U.S. Consulate General, Karachi

- 1) Walls and roof have evident seepage/leakage.
  - i) When was water/roof-heat proofing conducted?  
Roof treatment was done 6 years ago.
  - ii) If seepage occurred prior or after the waterproofing.  
Seepage occurred after waterproofing.

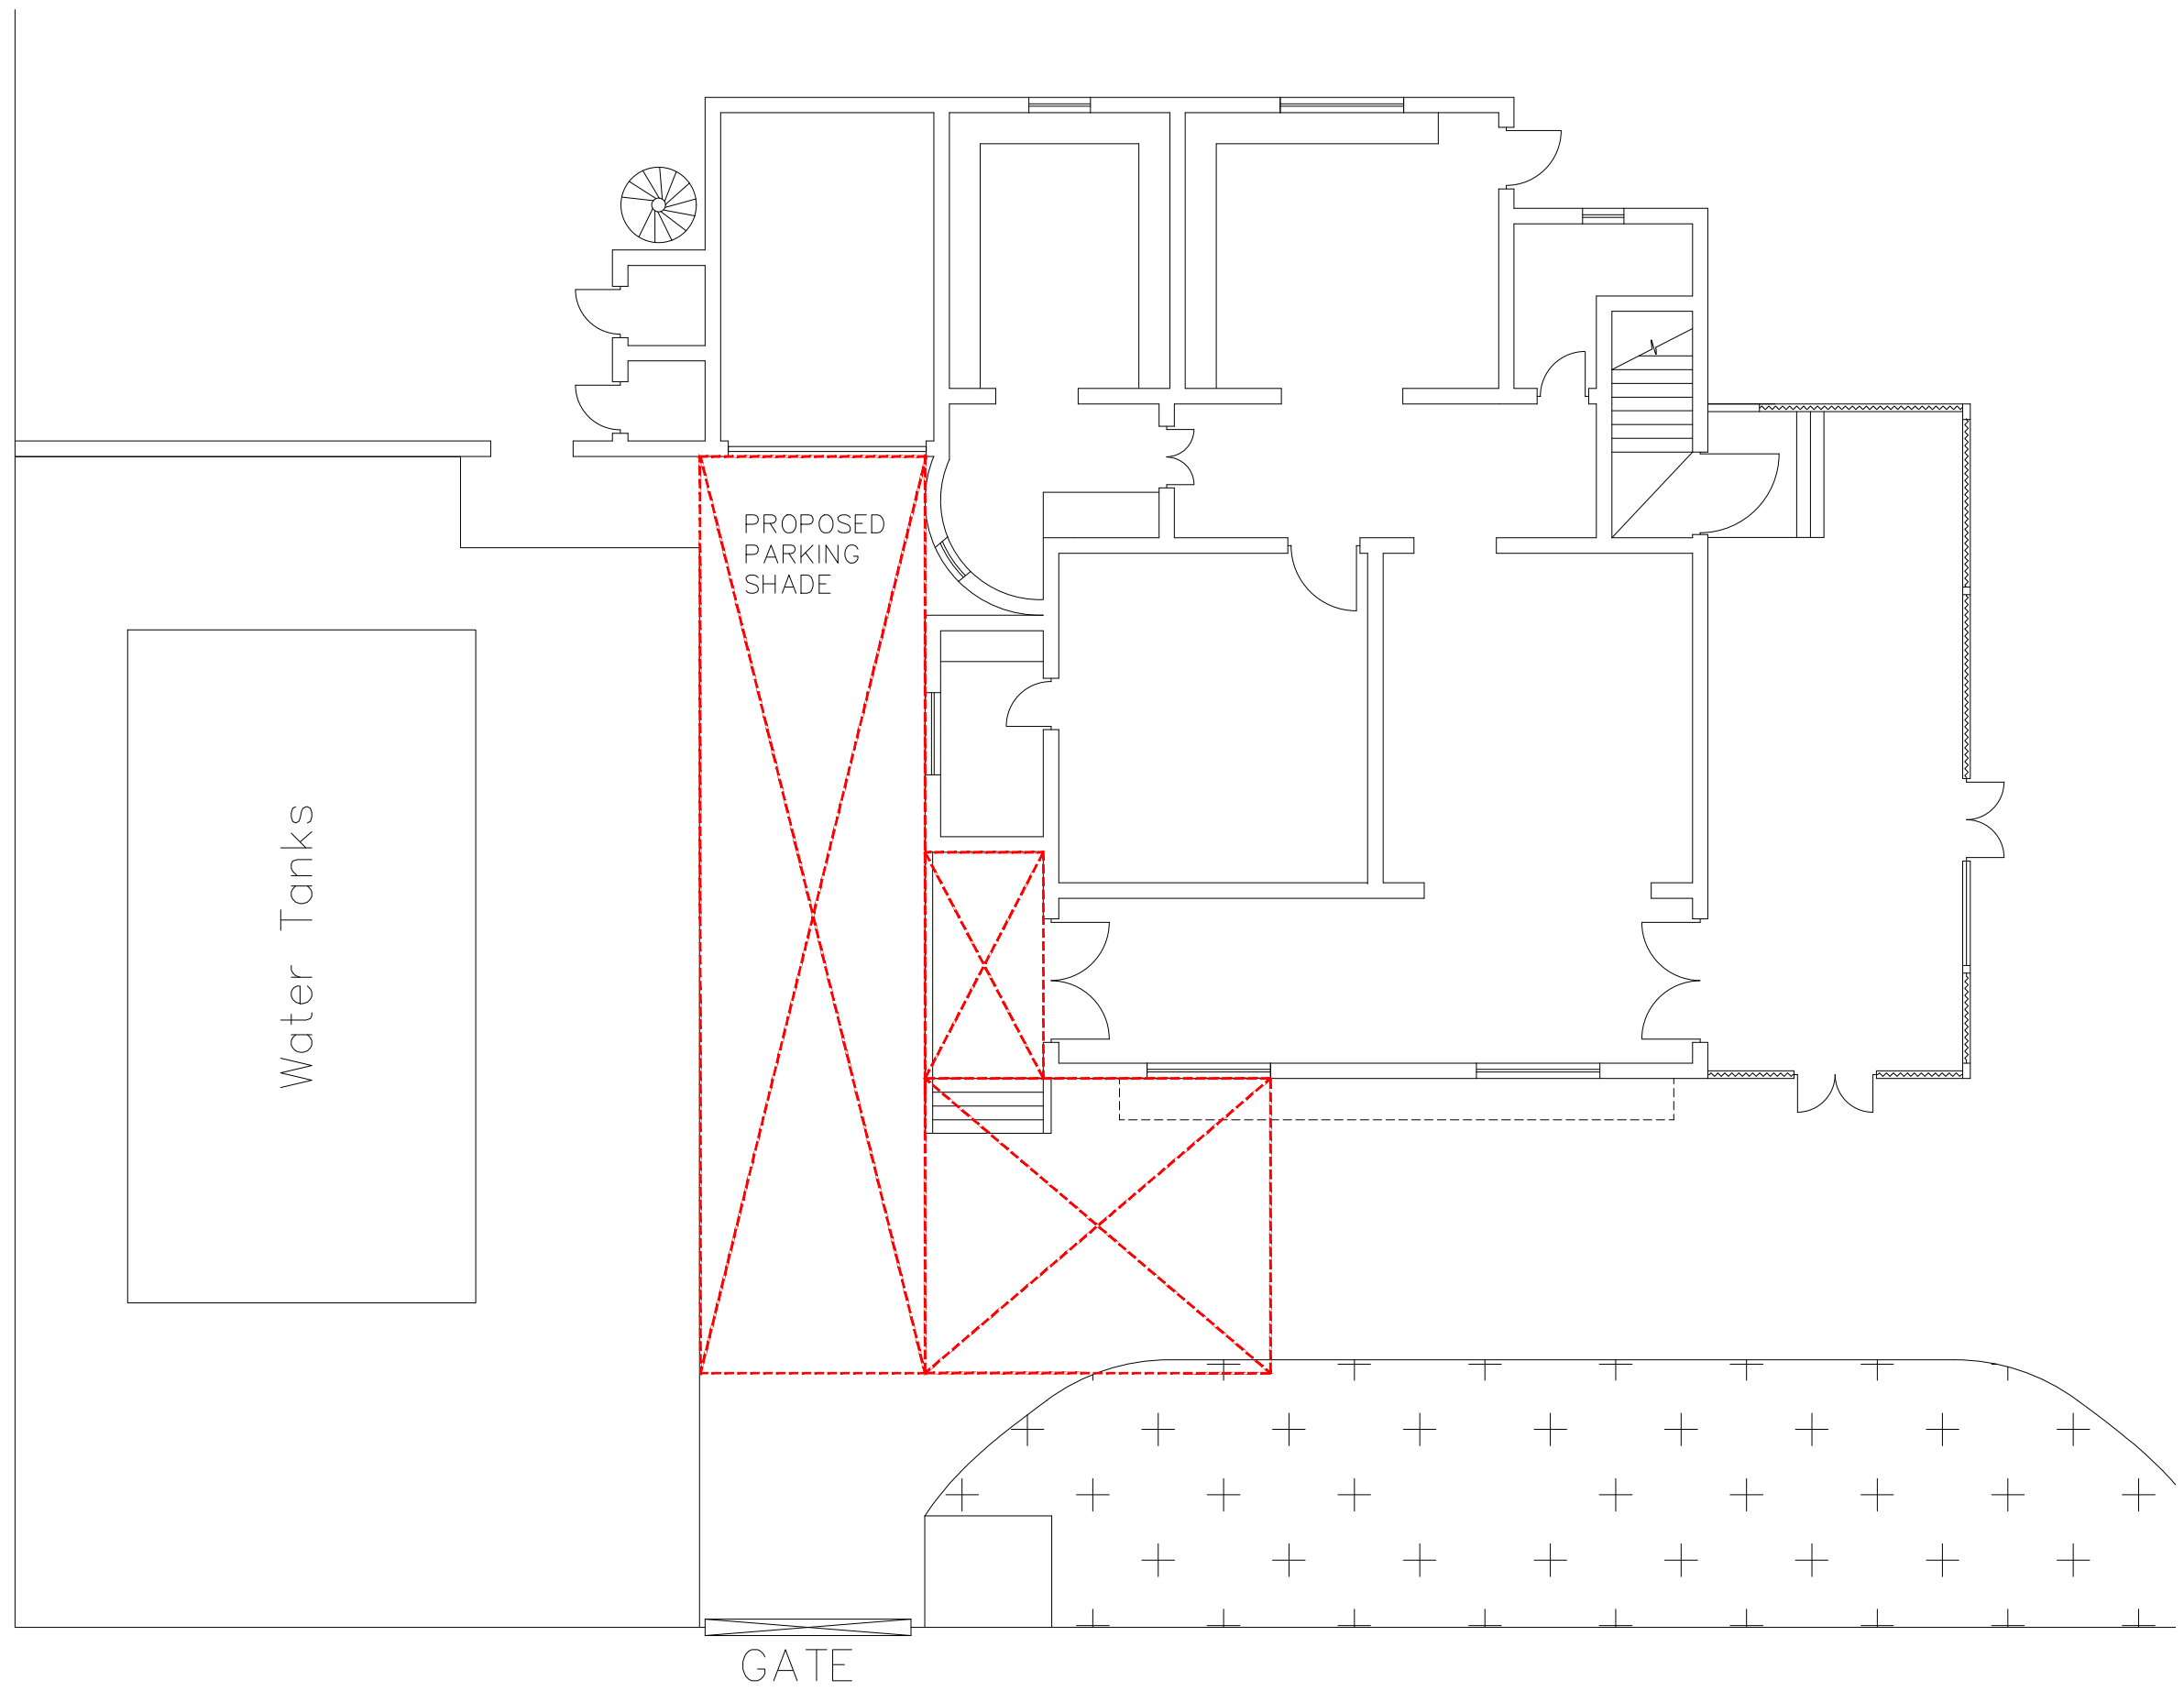
22) Kindly provide the size and specification of metallic ducts required for the air conditioning system. The Consulate only provides indoors and outdoors of the air conditioning units the cost of piping and UPVC trench work shall be in the contractor account.

**Only indoor (FCU/Evaporator along with wall brackets) and Outdoor (Condensing) units will be provided by post.**

**Yes, the cost of Piping and following is to be borne by the contractor in following considerations.**

**Items to be provided and installed by contractor as follows.**

- **Metallic duct for Refrigerant pipes**

(Duct Size 6"x6", Gauge thickness 18usg, Top cover to be removable i.e. screw fitting or metallic clips, Duct to be painted and finished as mentioned in BOQ).

All as per specifications in Electrical sections, sizing as per manufacturer recommendations and COR approval, Isolation switch sizing, placing, brand selection, supply & installation as per COR approval. HVAC Main and sub DBs/Panels as sizing, placing, brand selection, supply & installation as per COR approval.

**PROPOSED PARKING SHADE LAYOUT PLAN**

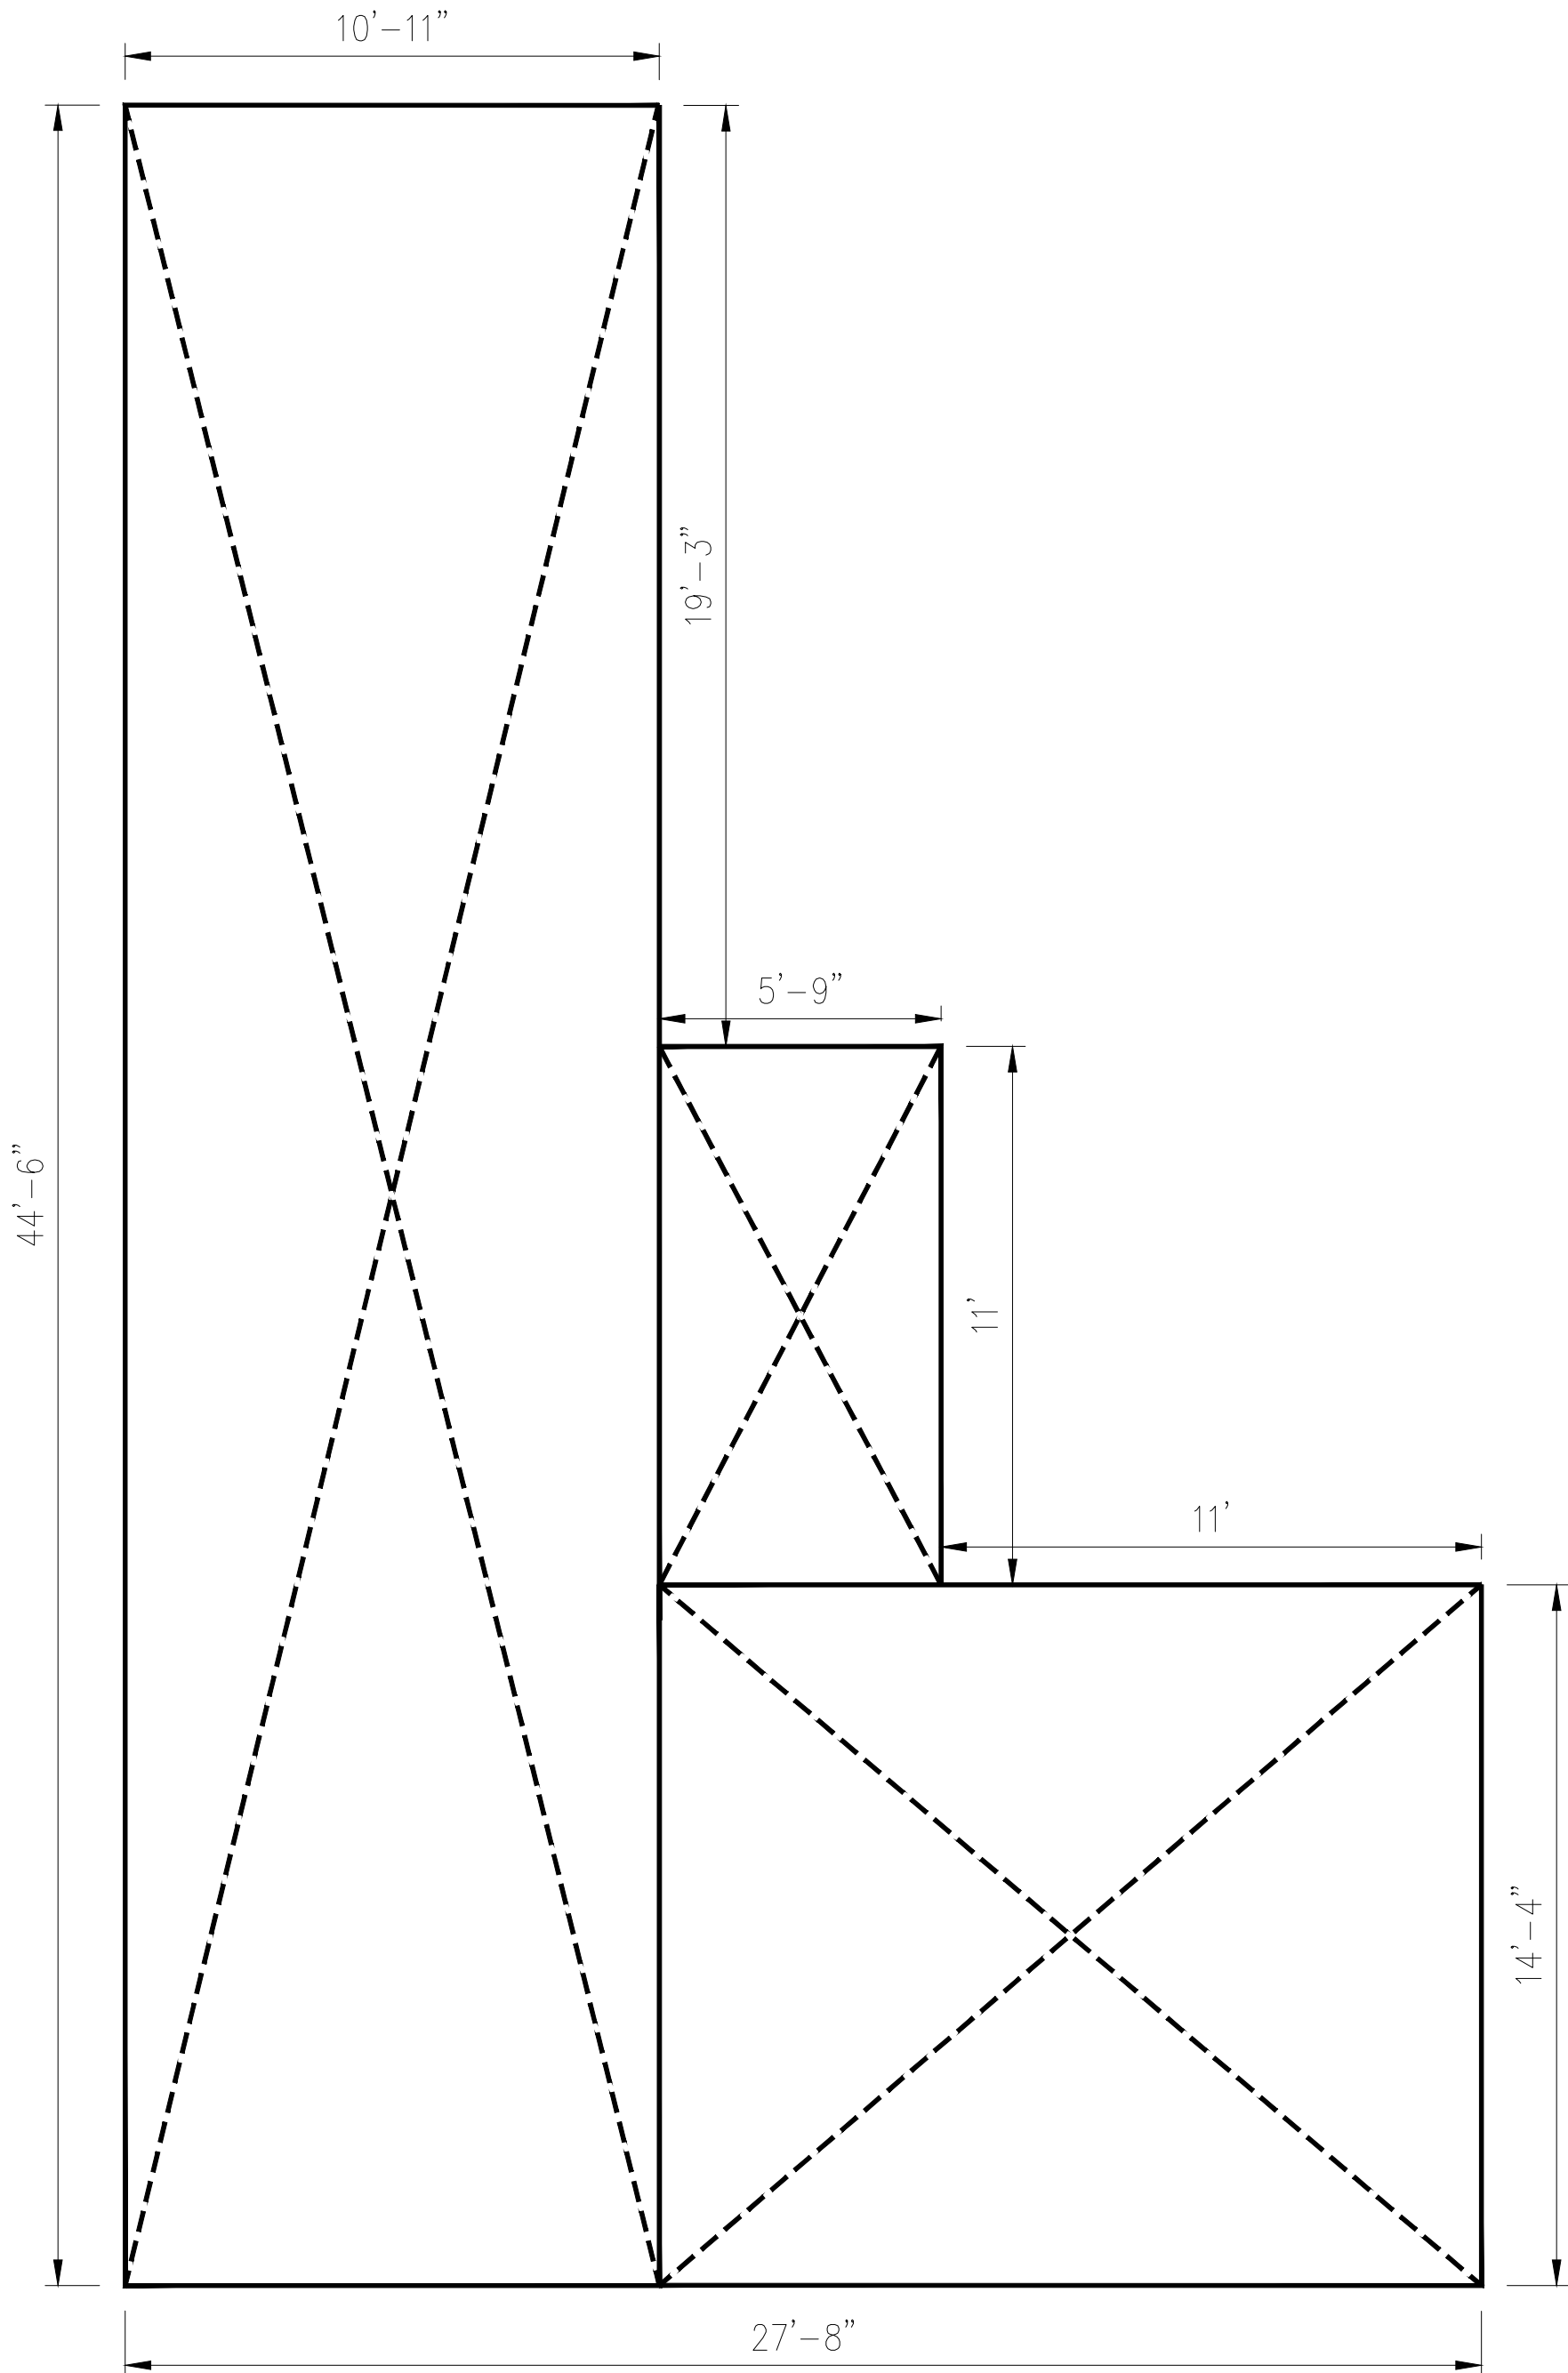
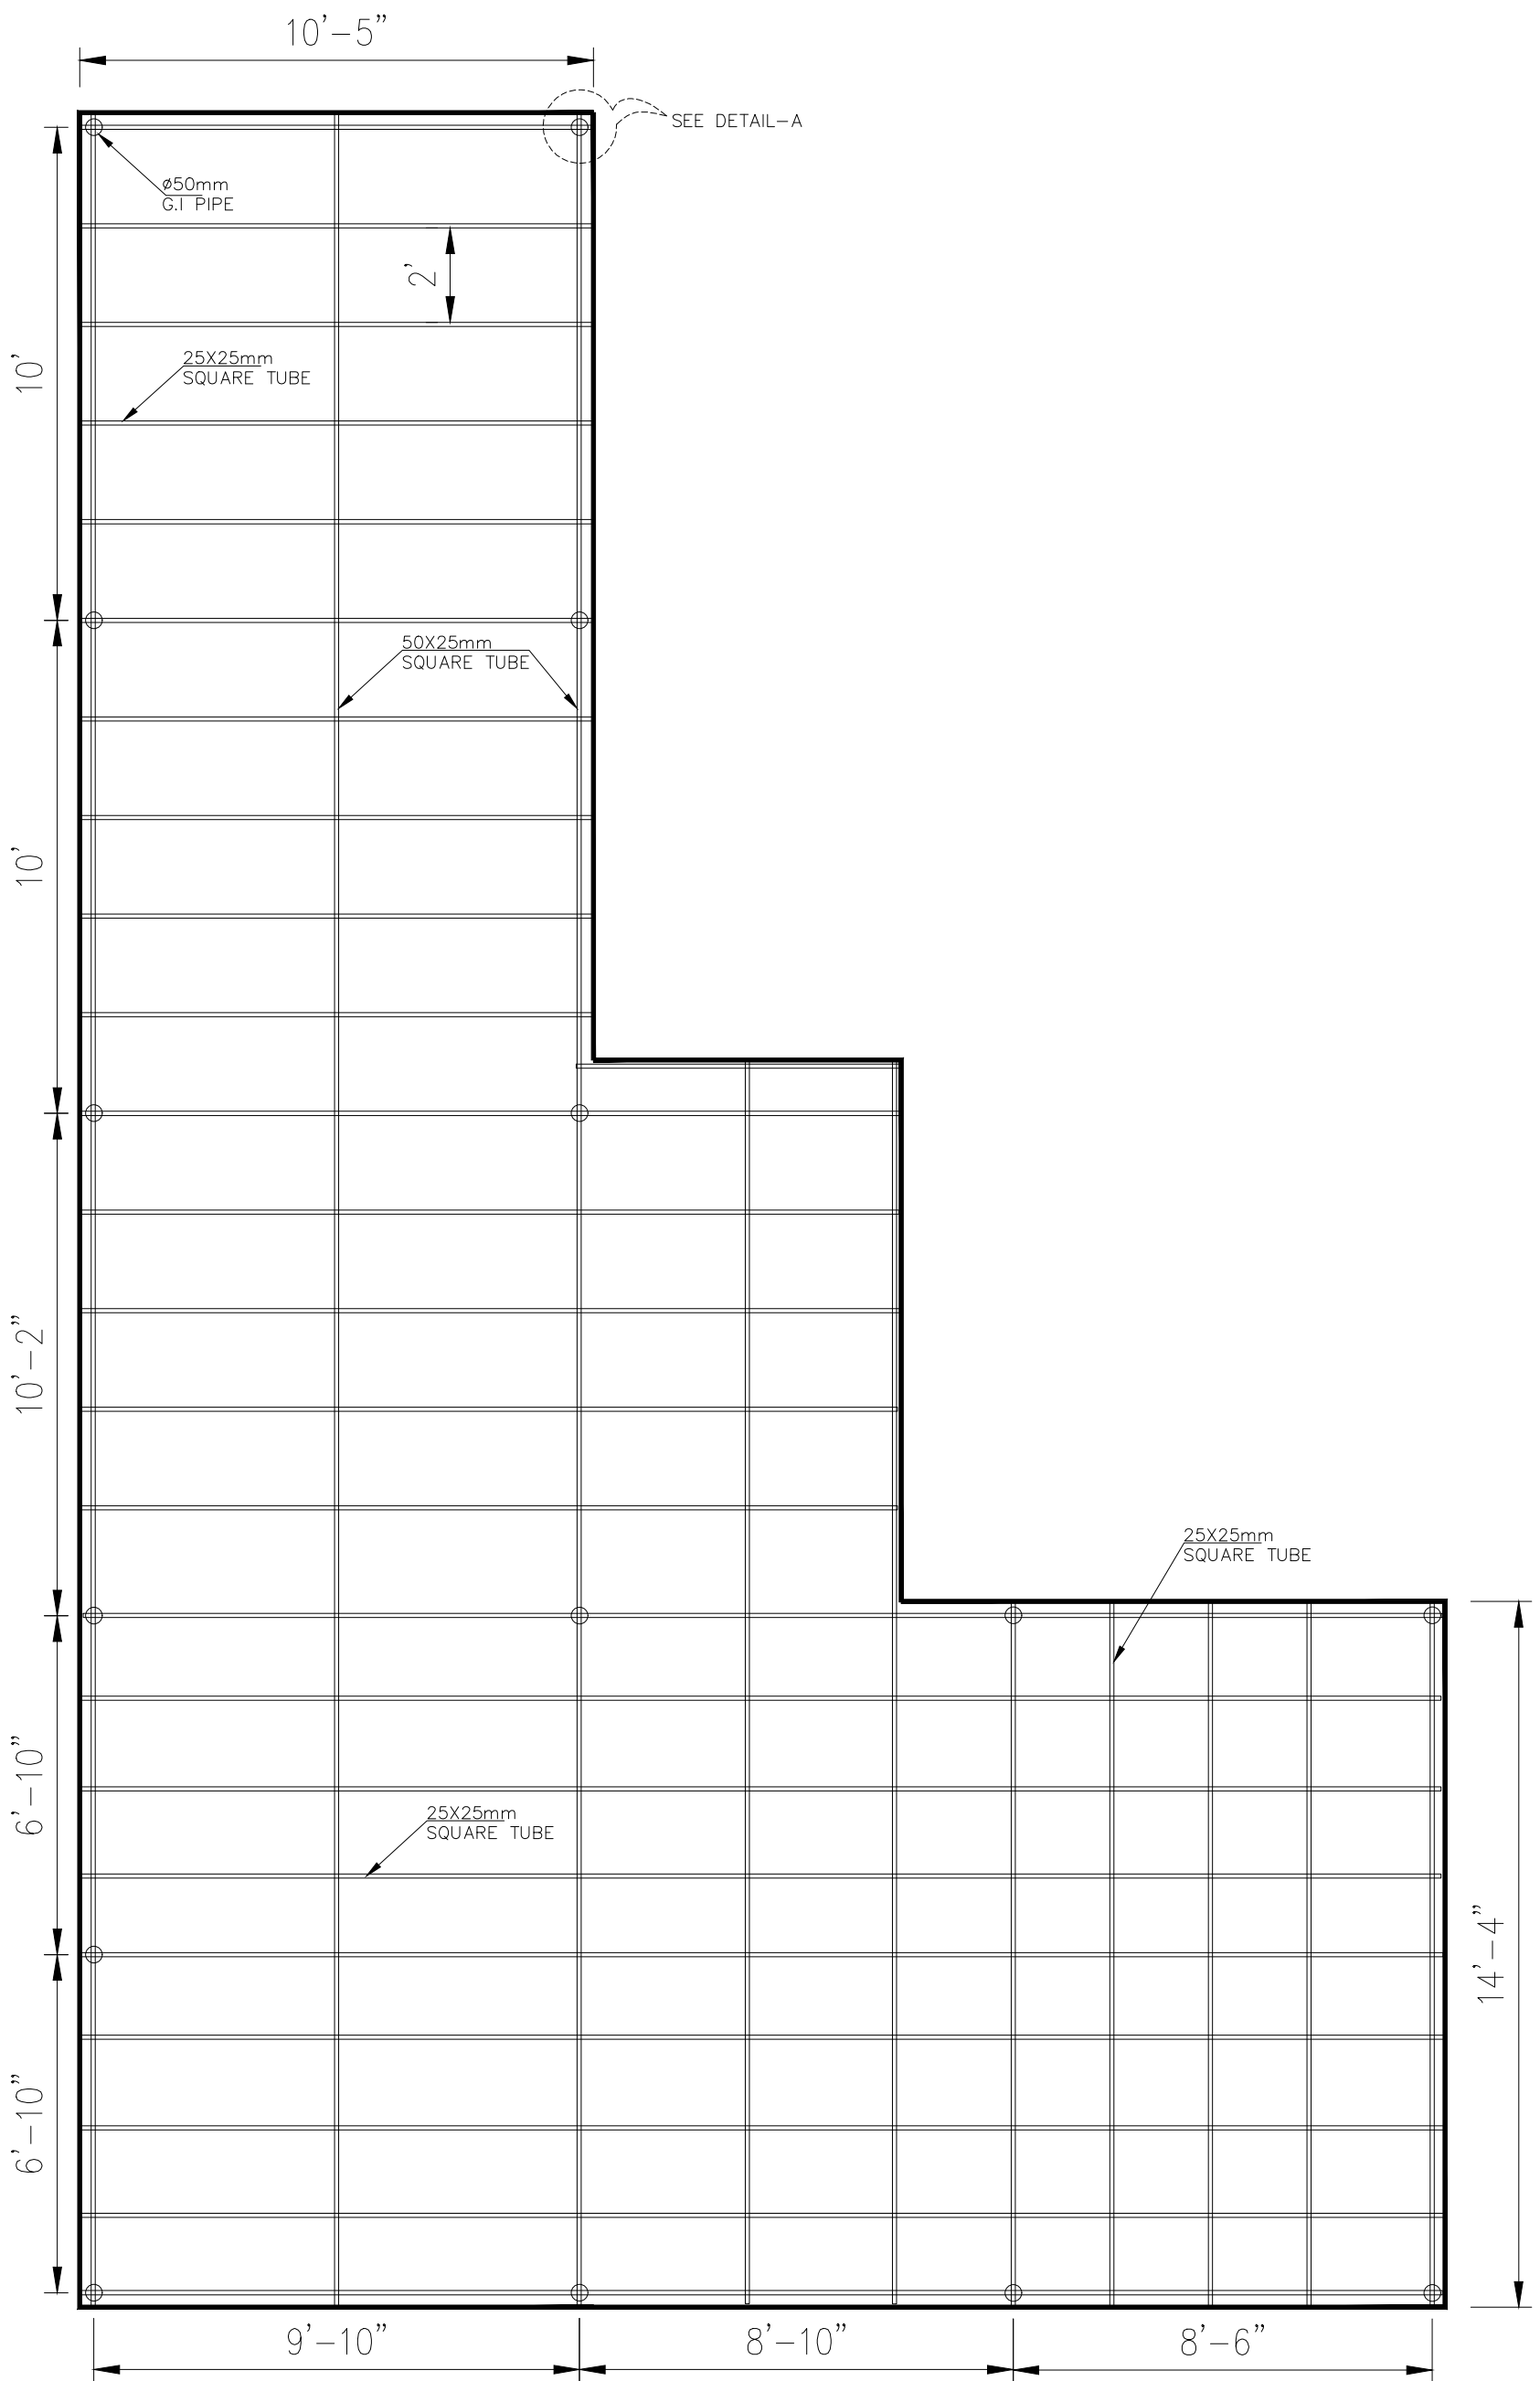
- 5) If one company is awarded both projects, do they start them simultaneously.  
Yes.
- 6) Share drawing/measurement of parking area shade.  
Drawing attached.
